UNITED STATES PATENT AND TRADEMARK OFFICE

APPLICATION NO.	FILING DATE	FIRST NAMED INVENTOR	ATTORNEY DOCKET NO.	CONFIRMATION NO.
10/561,725	03/08/2007	Andreas Pein	00599P0010US	8226

Office Action Summary	Application No. 10/561,725	Applicant(s) PEIN, ANDREAS	
	Examiner JONATHAN W. MILES	Art Unit 3731

DETAILED ACTION

**Image 1 from Gernlein Fig. 2**

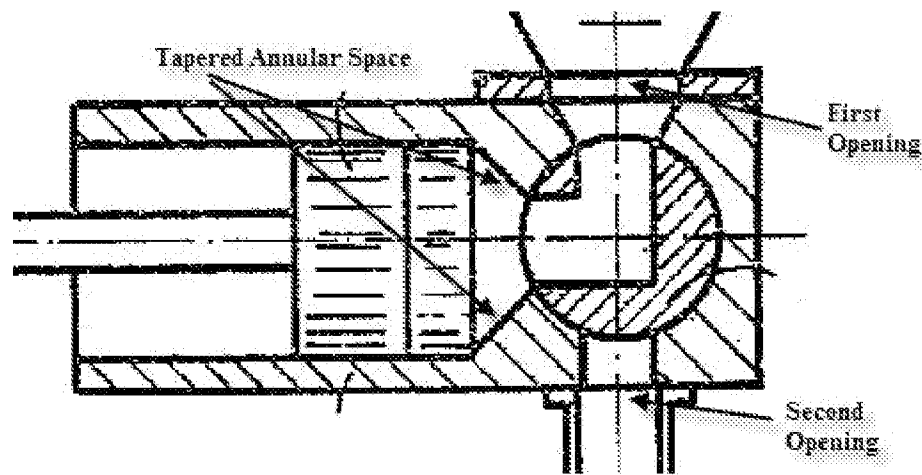
Regarding Claim 9, Yoder et al. in view of McDonnell et al. discloses the water jet apparatus according to claim 8, but does not disclose wherein at least a lowermost portion of the annular space tapers inwardly in a downward direction toward the suction-pressure space, the taper being formed by a frustoconical portion of the cylinder wall.

However, Gernlein discloses a fluid pump wherein the lowermost portion of the annular space tapers inwardly in a downward direction toward the suction-pressure space, the taper being formed by a frustoconical portion of the cylinder wall (see Image 1 above).

It would have been obvious to combine the tapered shape of Gernlein with the water jet apparatus of claim 8 because the shape prevents the piston from being extended any further. The motivation for the modification would have been to create a stop for the piston prior to extending all the way until it reaches the lowermost portion of the annular space.
